ORDER—dated 15th December 1883, No. 3593 W., Public Works.

**Jail at Ootacamund**

Estimate of Rs. 2,853, submitted by the Inspector-General of Jails for constructing quarters for eight warders of the —, sanctioned.

# Plan of Quarters for 8 Warders to be Built at District Jail Ootacamund

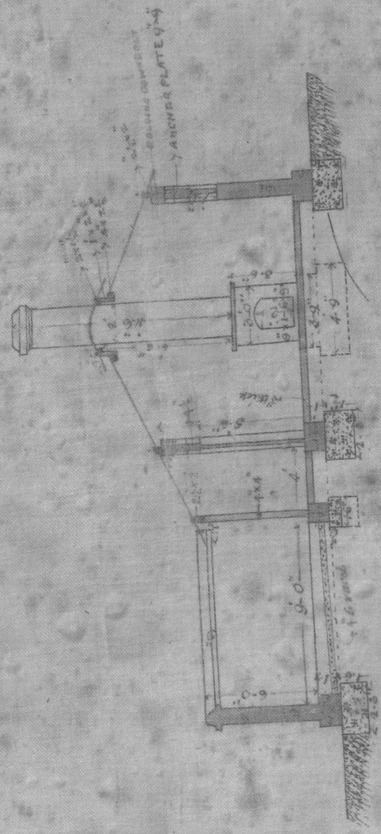
2. The design appearing to the Chief Engineer open to objection, the plan and estimate were forwarded to the Superintending Engineer, Fourth Circle, for check and revision.

You considered the plan unsuitable in certain respects, & sent the documents to the Supply Dept for revision, under endt No 1266 C of 5th July 93.

The Plan & Estimate appearing to me open to objection I forwarded same to S.E. & Circle for check & revision.

I at once applied for the original plan and estimate, as this plan submitted by the Executive Engineer appeared to me faulty in design whilst the estimate was in my opinion unnecessarily high. I was not able however that I succeeded in getting back the original plan and estimate.

10 As regards the design
the plan of the wooden lines is
similar to that of the Police huts
built by the D. P. W. the only
difference being that the Police
huts were first built without yards,
subsequently yards were added
by the Jail department. The plan
of the fences is the same. If
therefore my plan is faulty as
alleged, the original design of the
D. P. W. is faulty mine being a
copy. But as a matter of fact
the Police huts built upwards of
two years ago are all that can
be desired and, in my opinion
we cannot do better than follow
that plan.

3. The Superintending Engineer accordingly revised the plan and estimate, which after revision amounted to Rs. 3,200, and forwarded them to the Inspector-General of Jails for countersignature.

5. Under these circumstances, and seeing that an appropriation of funds was made to the work in G.O., No. 2276 W., dated 15th August 1883, the original estimate, amounting to Rs. 2,853 is now formally sanctioned. A further appropriation of Rs. 188 is made from the Provincial reserve for the completion of the work.

The draft S.O. will have to be modified accordingly — and the completion of the work according to original design recognised.
